**PETITION FOR DECLARATORY STATEMENT
BEFORE THE FLORIDA DEPARTMENT OF FINANCIAL SERVICES**

PETITION FOR DECLARATORY STATEMENT

Waldrop Center Office Building – 28100 Bonita Grande Dr. Bonita Springs, FL 34135

RE: Waldrop Center Office Building, 28100 Bonita Grande Drive, three-story building

Exhibit A 1-1

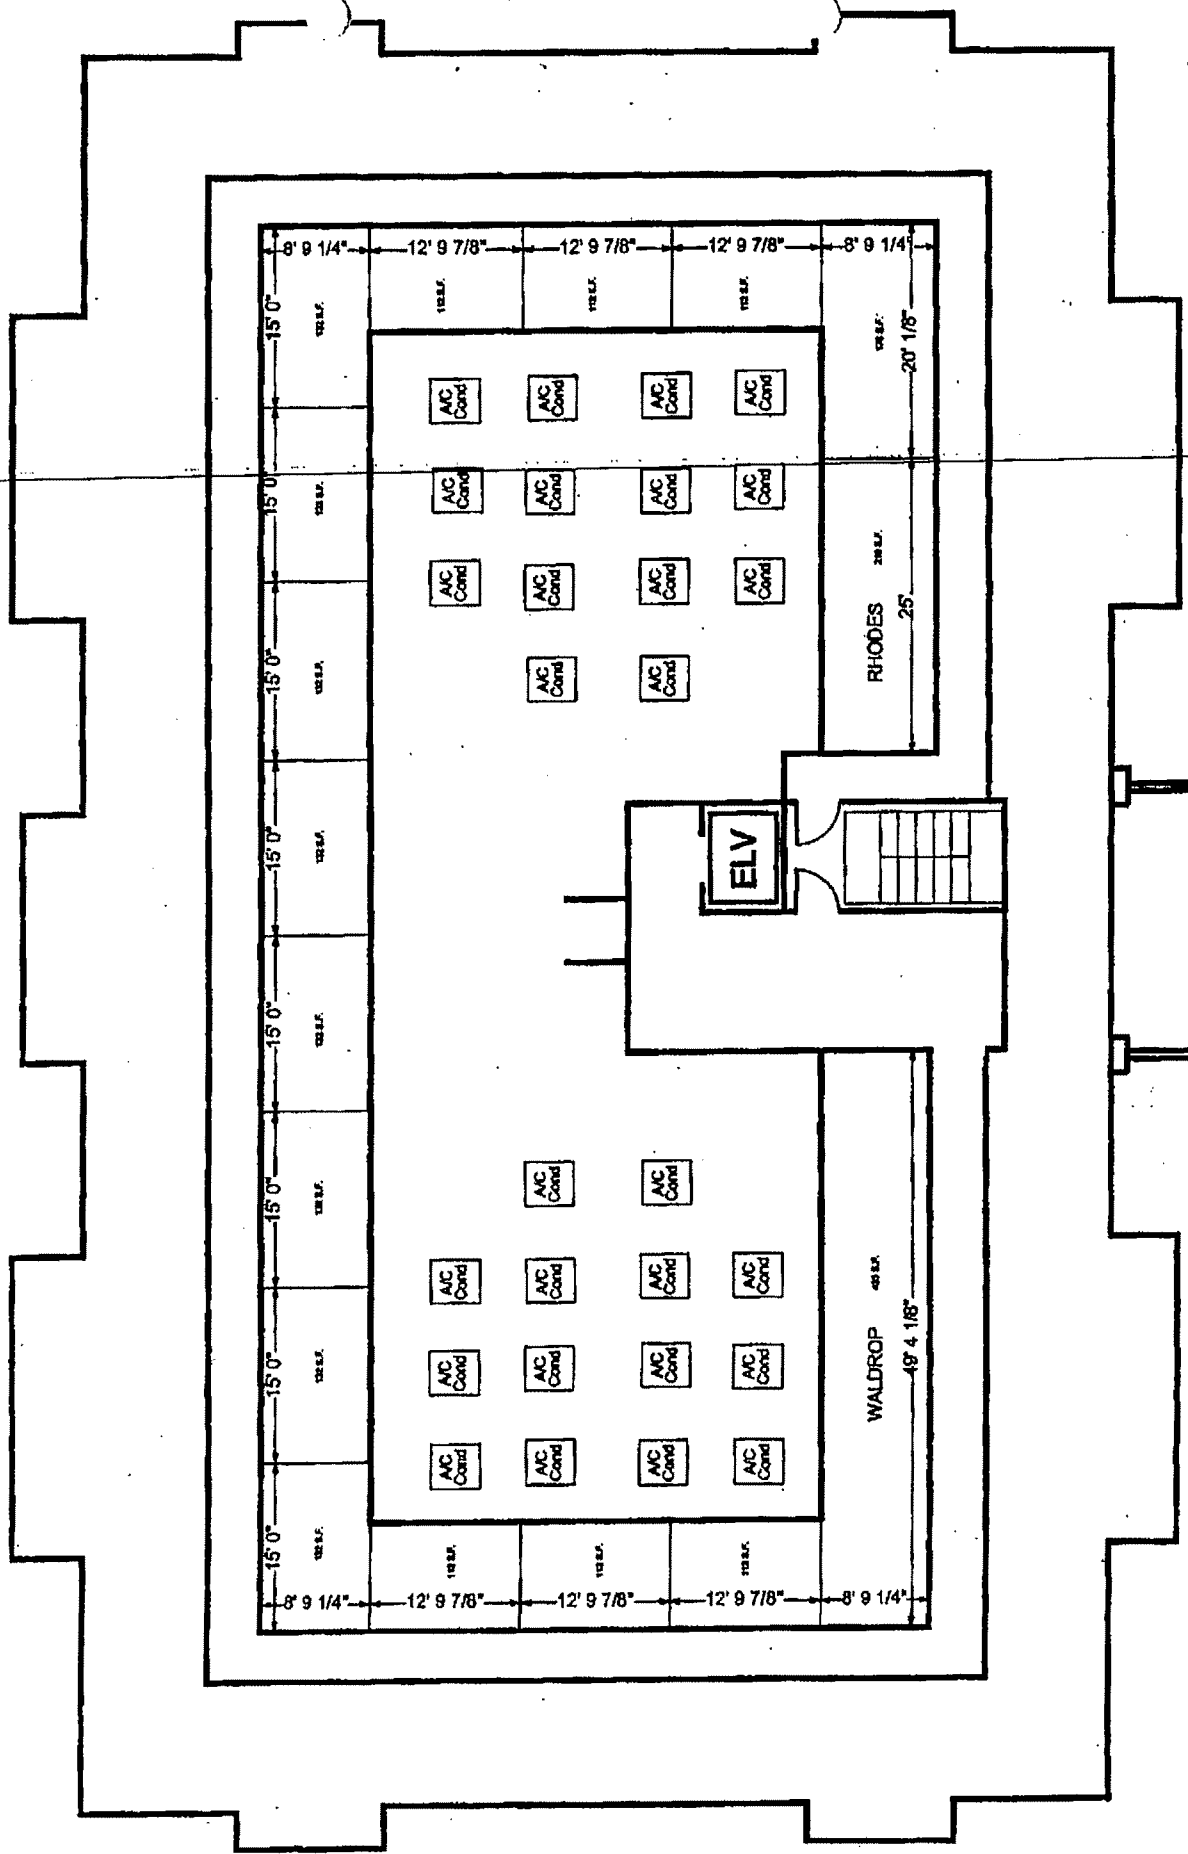
1. Can the local authority having jurisdiction waive code safety requirements that are specifically provided by Code? FFPC NFPA 101 4.6.1 thru 4.6.1.3
2. From a review of Exhibit A, does the single stair (means of egress) with two exit doors comply with code section FFPC NFPA 101 38.2.4.1?

2. From a review of Exhibit A, does the single stair (means of egress) with two exit doors comply with code section FFPC NFPA 101 38.2.4.1?

The attic area is only accessible to one means of egress (stair), and not two separate means of egress as required by Code. The two doors on the existing stair does not count as two separate means of egress as defined by FFPC NFPA 101 3.3.151, but would be two separate exit doors into one means of egress that discharges out of the building.

The Code requires two Means of Egress that are continuous and discharges to the public way. Therefore, in order to convert the attic space into another floor that would be used for incidental storage to the Business Occupancy, another separate Means of Egress needs to be provided. Also, please keep in mind that there other applicable Fire or Building Codes that would apply here if the attic space is converted into another floor.

The attic space of your building cannot be used for incidental storage to business occupancy (your building) because there are not two separate means of egress (stairs) provided on that level. If you decide to add another separate means of egress (stair), then I will discuss the other applicable Fire Codes that will apply. Please keep in mind that the Building Code has applicable codes that would also apply, and can only be enforced by the Building Official.
